UNITED STATES PATENT AND TRADEMARK OFFICE

Office Action Summary

10/750,433

1. The amendment after final filed on August 24, 2007 has been entered.
2. The final rejection on May 9, 2007 is withdrawn and replaced by the instant final rejection.
3. The text of those sections of Title 35, U.S. Code not included in this action can be found in a prior Office action.
4. Claims 18, 20, and 23-25 are rejected under 35 U.S.C. 112, second paragraph, as being indefinite for failing to particularly point out and distinctly claim the subject matter which applicant regards as the invention.

ATTACHMENT

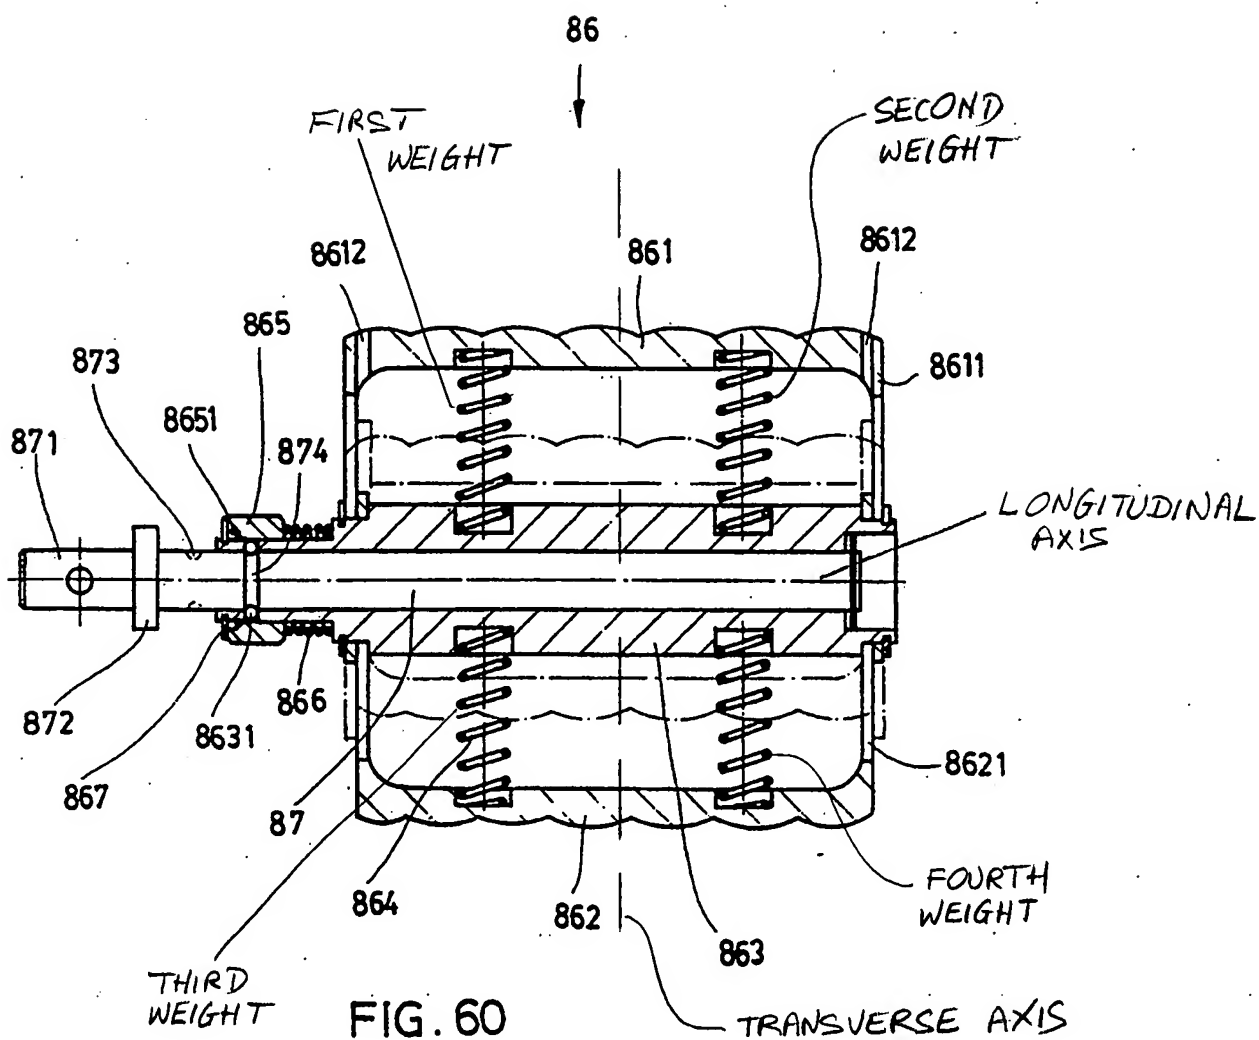
Regarding Claim 18, Chang teaches, in FIGS. 57-63, a reversible foot pedal 86 (id. col. 17, line 56+) comprising:

a pedal body 861, 862 having a first surface (see FIGS. 61-63 in Attachment hereinafter "Att.") and a second surface (Att.) oppositely disposed from said first surface (Att.); and,

said pedal body 861, 862 having a longitudinal axis (FIG. 60 in Att.) and a transverse axis (Att.), said transverse axis (Att.) being perpendicular to said longitudinal axis (Att.), said pedal body 861, 862 further comprising a first weight 864 (FIG. 60 in Att.) and a second weight

864 (Att.) operatively connected to said pedal body 861, 862, such that one of said surfaces (FIGS. 61-63 in Att.) faces substantially upwards as said pedal body 861, 862 approaches an equilibrium position, said first weight 864 (Att.) and said second weight 864 (Att.) being oppositely disposed and substantially equidistant from said transverse axis (Att.), said pedal body 861, 862 further comprising a third weight 864 (FIG. 60 in Att.) and a fourth weight 864 (FIG. 60 in Att.) operatively connected to said pedal body 861, 862, said third weight 864 (Att.) and said fourth weight 864 (Att.) being oppositely disposed and substantially equidistant from said transverse axis (Att.).

As noted, Chang's elements 864 must have an amount or quantity of heaviness, i.e., mass or weight. Therefore, the elements 864 "read on" the claimed weight. In summary, Chang teaches the invention as claimed except the securing means.

Regarding Claim 20, Chang's first surface (Att.) is adapted to contact an associated foot and Chang's second surface (Att.) is adapted to contact an associated shoe. It has long been held that the recitation that an element is "adapted to" perform a function is not a positive limitation but only requires the ability to so perform. It does not constitute a limitation in any patentable sense. *In re Hutchison*, 69 USPQ 138 (CCPA 1946).

Regarding Claim 24, Chang's first, second, third and fourth weights 864 (FIG. 60 in Att.) inherently have diameters. However, the diameters of Chang's third and fourth weights are equal to the diameters of Chang's first and second weights.
